## Product Change Notice (PCN)

PCN Number: **PCN-0450972R-01**

Product(s) Affected: *SJ1-351XN Series. (SJ1-3513N, SJ1-3514N, SJ1-3515N)*

PREVIOUS CUI DEVICES DETAIL / IMAGE			NEW CUI DEVICES DETAIL / IMAGE

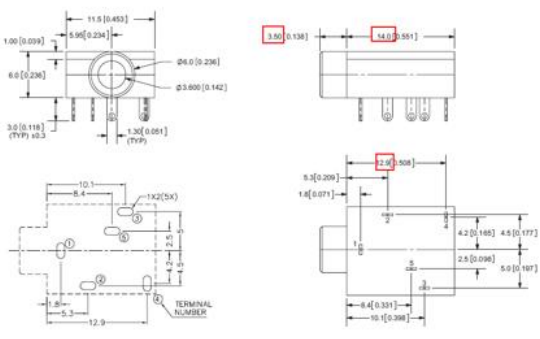
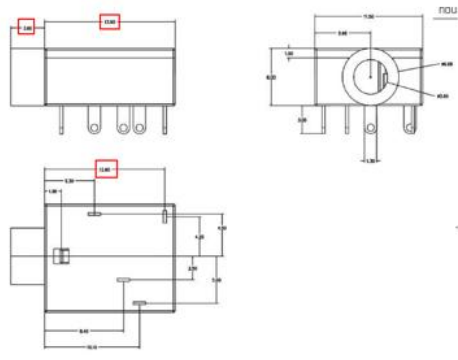
Description of Change: *Slight Dimensional difference. Terminal Material Change See image Below*

MATERIAL	PLATING	DESCRIPTION	MATERIAL	PLATING/COLOR
terminal 1	brass	silver	terminal 1	brass t=0.3	silver
terminal 2	brass	silver	terminal 2	phosphor bronze t=0.3	silver
terminal 3	brass	silver	terminal 3	brass t=0.3	silver
terminal 4	brass	silver	terminal 4	brass t=0.3	silver
terminal 5	brass	silver	terminal 5	phosphor bronze t=0.3	silver
bushing	brass	nickel	bushing	brass	nickel
spring	stainless steel		spring	steel	black
cover	PBT		cover	PBT (UL94V-0)	black
plastic	PBT		housing	PBT (UL94V-0)	black
